## VILLAS AT STONEBROOK JSP17-62

Public hearing at the request of Pulte Home of Michigan, LLC for recommendation to the City Council for Concept Plan approval under the Planned Suburban Low Rise Overlay District. The subject property is located on the east side of Wixom Road, north of Eleven Mile Road (Section 17). The applicant is proposing a 43 duplex (86 total units) "age-restricted" ranch style housing units. The subject property is currently zoned I-2, General Industrial with Planned Suburban Low-Rise Overlay.

## PLANNING REVIEW

# PLAN REVIEW CENTER REPORT

PULTE HOMES  
WIXOM ROAD  
MULTI-FAMILY  
PSLR OVERLAY CONCEPT PLAN  
LAYOUT PLAN

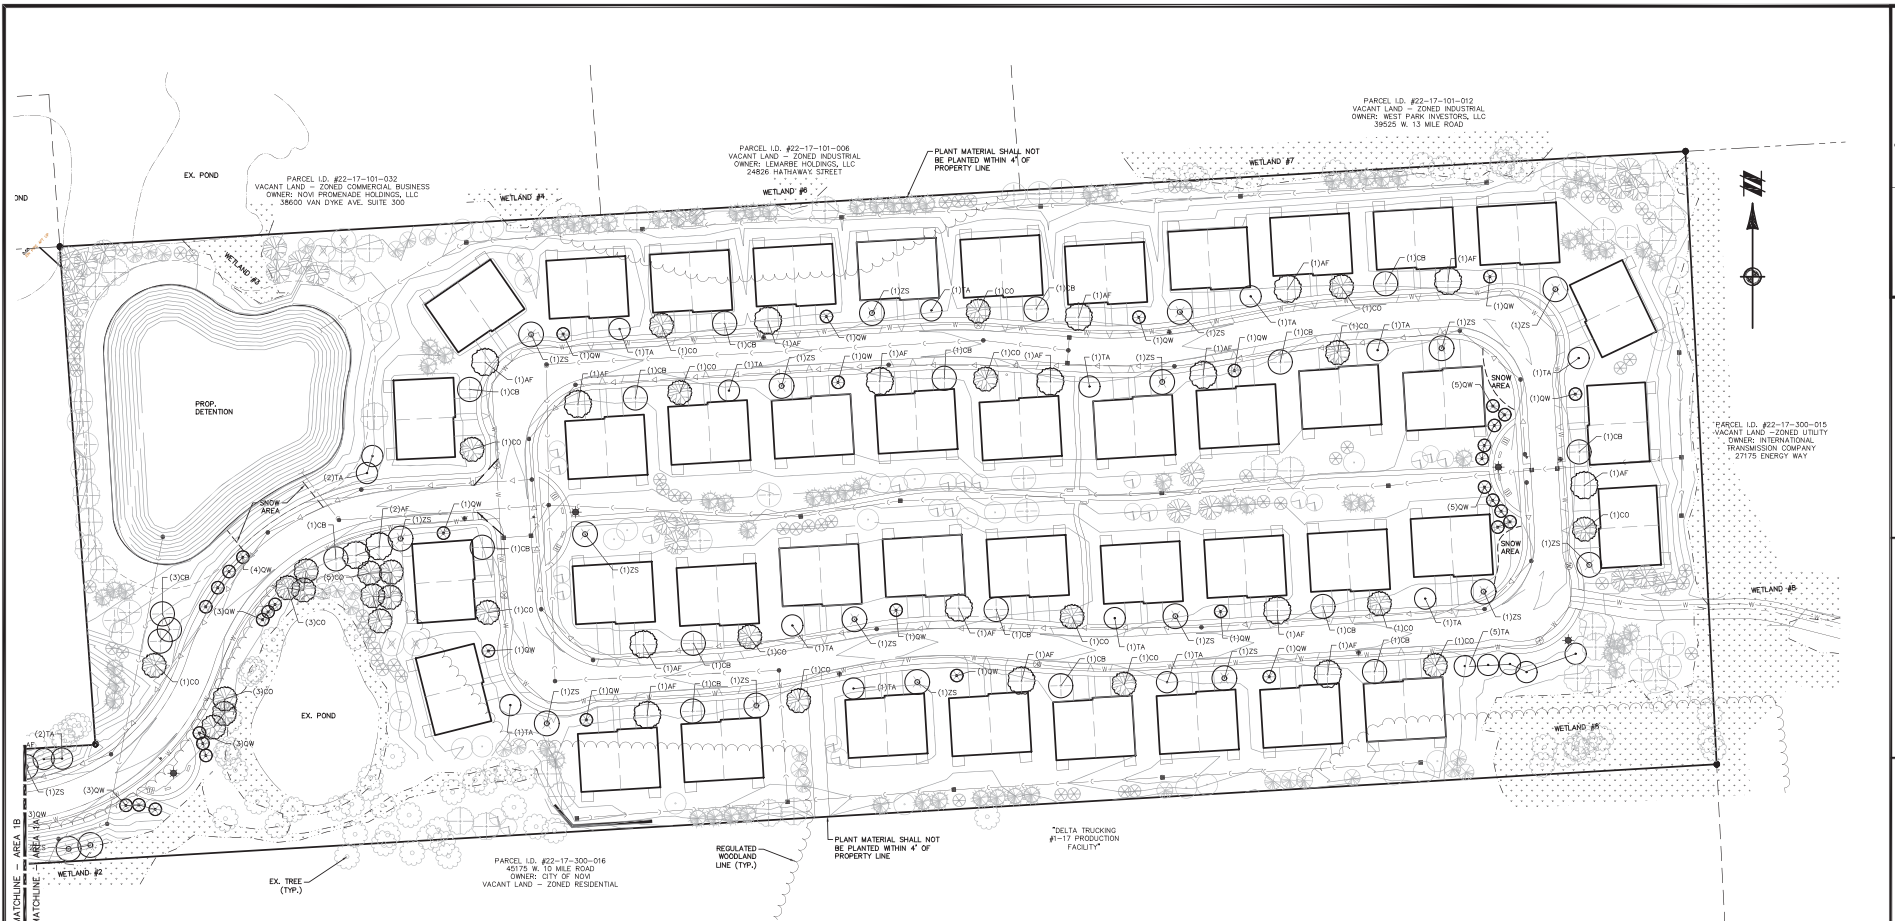
- The applicant should update the proposed boulevard cross-section detail on Sheet 13 to reflect the dimensions indicated on Sheet 05.
- Although not warranted by the data presented in the TIA, the applicant has proposed both an entering and exiting right turn lane. Both lanes are designed in compliance with City standards.

**Response:** *Bicycle parking has been shown on sheet 05 of the last Concept Plan submittal. Refer to traffic review comments.*

**Response:** *A street naming application has been submitted and the road names shown on sheet 05 have been approved by the street naming committee.*

**Response:** *A 25-foot vegetated buffer is designated and shown on sheet 05 of the plans. This buffer does not encroach into the lots.*
- **Comment:** The northeast corner should be captured in the on-site storm sewer and storm water management basin. Alternatively, rain gardens can be proposed in this area.

**Figure 1.** City of Novi Regulated Wetland & Woodland GIS Coverage Map (approximate project boundary shown in red). Regulated Woodland areas are shown in green and regulated Wetland areas are shown in blue.

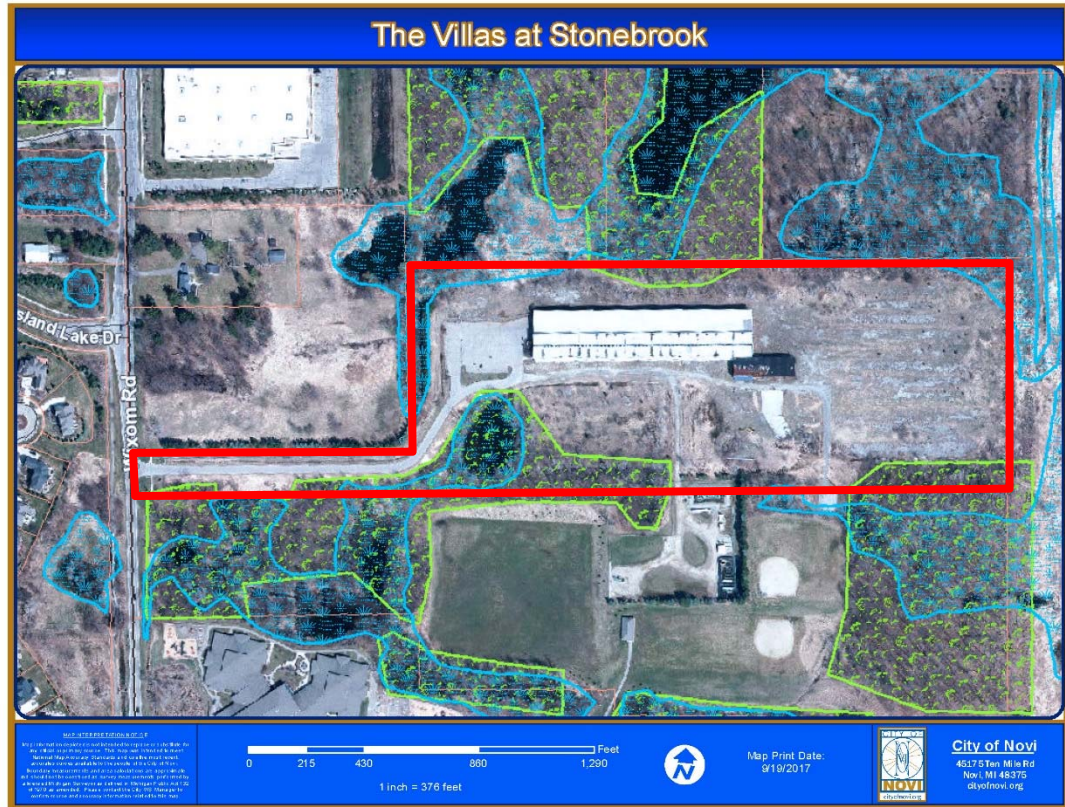
The Plan indicates numerous areas of existing wetlands on the site. In general, these wetland areas are located along the perimeter of the project site. Portions of these wetland areas appear to be included on the City of Novi Regulated Wetlands and Watercourse Map (see Figure 1, attached).

The MDEQ generally requires mitigation for impacts greater than one-third (0.33) acre and the City usually requires mitigation for impacts greater than one-quarter (0.25) acre. The Plan (*Existing Conditions Plan*, Sheet 02) notes that 0.81-acre of compensatory wetland mitigation is to be provided off-site. Subsequent plan submittals shall provide additional details regarding the location of the proposed wetland mitigation area. Mitigation for impacts to emergent and/or scrub shrub wetlands shall be mitigated for at a ratio of 1.5-to-1.

**Figure 1.** City of Novi Regulated Wetland & Woodland Map (approximate project boundary shown in red). Regulated Woodland areas are shown in green and regulated Wetland areas are shown in blue.

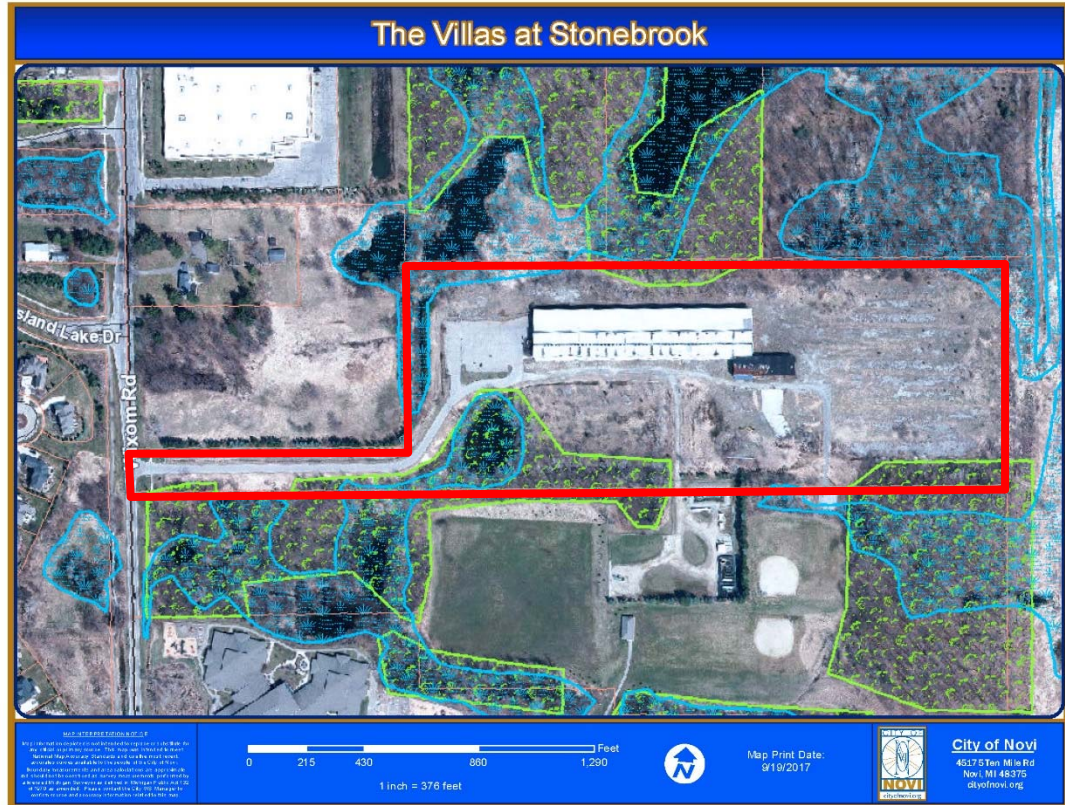
In addition to review of the current Revised Concept Plan, ECT's in-office review of available materials included the City of Novi Regulated Woodland map and other available mapping. The subject property includes area that is indicated as City-regulated woodland on the official City of Novi Regulated Wetland and Watercourse Map (see Figure 1). The areas designated as City Regulated Woodlands area located along the northern (central) and southern edge of the subject property.

The Landscape Plan (Sheet 09) notes that 118 Woodland Replacement Tree credits are required and that a total of 118 on-site Woodland Replacement Tree credits are proposed. These are noted as being a mix of canopy deciduous, evergreen, and sub-canopy trees. The Plan does not currently appear to provide the quantity, species, locations and sizes of the proposed Woodland Replacement material. Subsequent site Plans should include this information. The Plan should clearly indicate the locations, sizes, species and quantities of all woodland replacement trees to be planted on-site. The applicant should review and revise the Plan in order to better indicate how the on-site Woodland Replacement requirements will be met.
